# 2014 - 2015 Corvette: GM TechLink: Break-In Oil Change for Corvette Included in Chevrolet Complete Care Program

**Subject:** Break-In Oil Change for Corvette Included in Chevrolet Complete Care Program

**Model and Year:** 2014 - 2015 Chevrolet Corvette Stingray with Z51 and Z06 Models

**Date:** January 22, 2015

**Fig. 2**

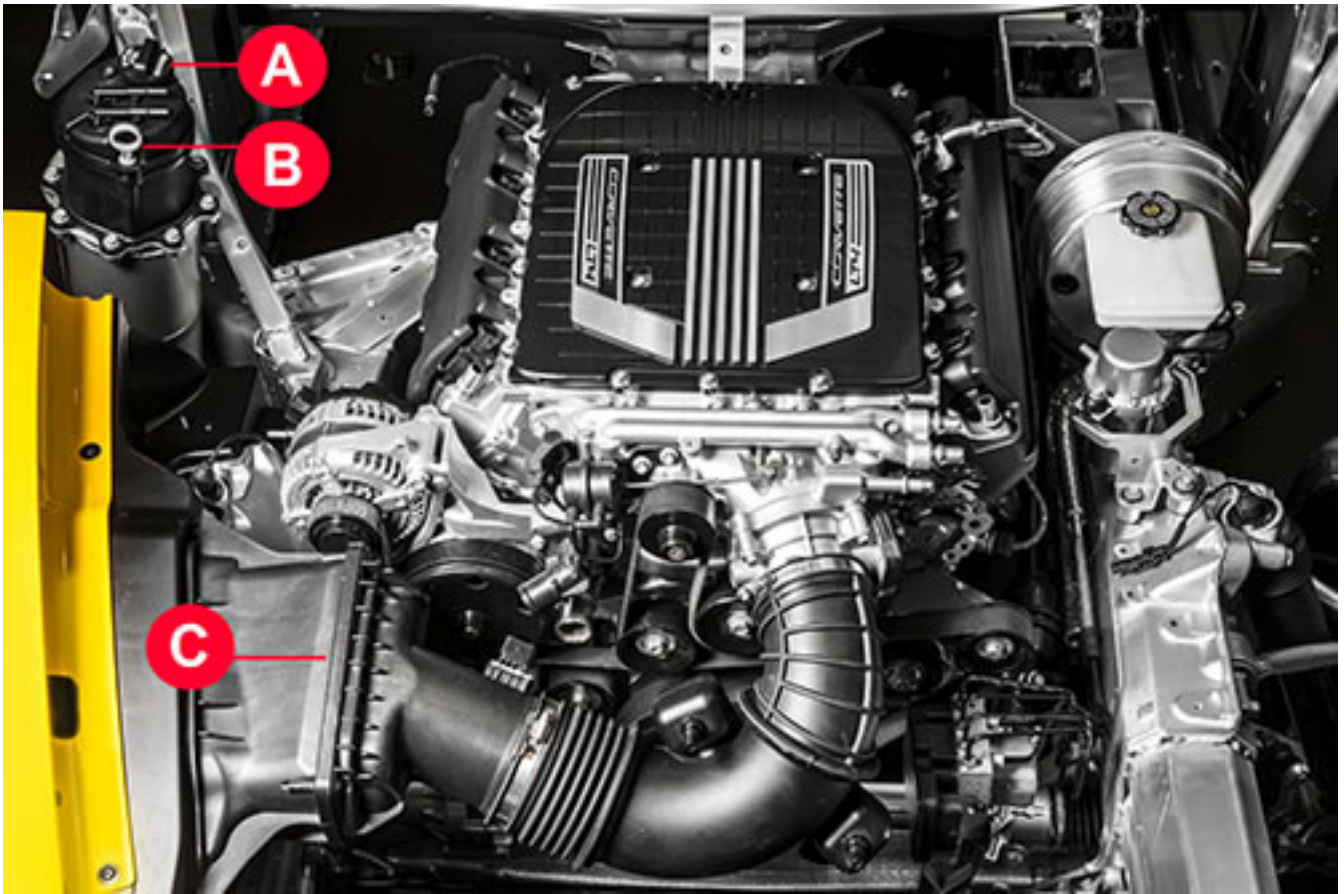
A new mileage interval has been established for the first engine oil change on 2014-2015 Corvette Stingray models with the Z51 Performance Package and Z06 models. These vehicles are equipped with an engine featuring a dry sump oil system. The first oil change should take place at 500 miles (800 km) on these vehicles.

If the vehicle is driven continuously at a high engine speed with the first factory oil fill, silicone sealants in the engine's gaskets may degrade the anti-foaming properties of the oil. This may lead to oil leaking out from the air cleaner assembly due to the oil foaming condition. The oil foam does not affect the engine's durability, but changing the oil at 500 miles will help prevent oil foaming in the future because the silicone sealants are removed with the original oil.
